17 December 2020

SUBMISSION: DRAFT MAMRE ROAD DEVELOPMENT CONTROL PLAN

Figure 1 Road Network Plan

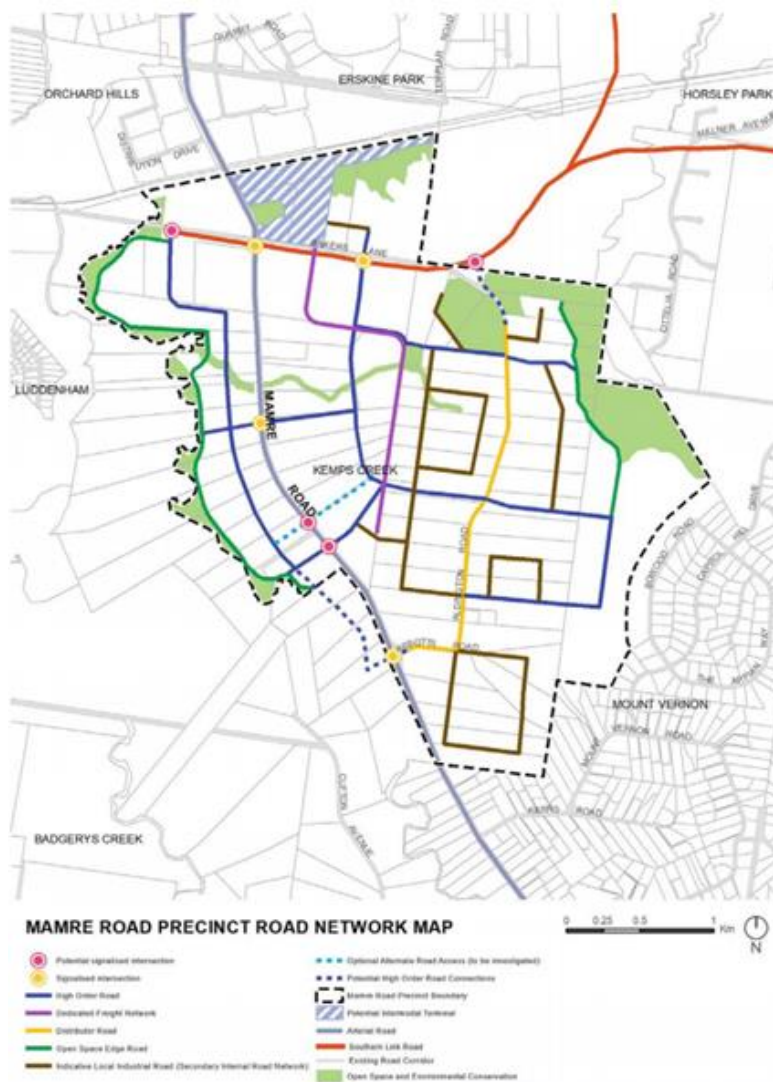
The identification of this road network is premature, as it is understood transport modelling is currently underway. The DPIE must share the results of this transport modelling with every landowner within the Mamre Road Precinct. It is critical for each landowner to understand the nexus between the transport modelling, and the identified roads in the Road Network Plan contained in the DCP.

In addition to the broader modelling, there are discrepancies between the naming of road typologies in the road sections, and the road classifications used in the Road Network Plan. In order to minimise confusion, the Road Network Plan must be updated to reflect the terminology associated with the road sections.

5. **The High-Order Road which runs along the south-eastern boundary of 706-752 Mamre Road is completely within our boundary – it would be equitable if this road were shifted south so that the road area and the intersection were split 50/50 between our site and the neighbouring site to the south. Alternatively, the width of the combined high-order road and dedicated freight line should be split 50/50 between our site and the neighbouring site.**

The DCP identifies a dedicated freight network, which intends to service the future intermodal terminal. The Road Network Plan shows that this dedicated Freight Network traverses through the centre of the precinct to Bakers Lane, connecting to the potential intermodal terminal.

- How is the dedicated freight network intended to interact with other roads?
- When the dedicated freight road crosses another road, which road reserve is given priority?
- How will this corridor interface with the adjoining industrial land and what restrictions might this present?
- What utilisation of the land will be permitted in the interim?

1. **The transport modelling must be shared to the land owners to understand how this modelling will inform the Transport Network section within the DCP.**

2. **The Transport Network section must be reviewed and updated once the transport modelling is complete for the Precinct.**
3. **The naming terminology used in the road sections must be aligned to minimise misinterpretation. Therefore, it is recommended for Road Network Plan to adopt the road section references.**

4. **The DCP must allow an interim access arrangements for the site off Bakers Lane or Mamre Road to cater for construction and industrial purposes until such time design is complete and funding is allocated to deliver upgrades for Mamre Road and Southern Link Road.**
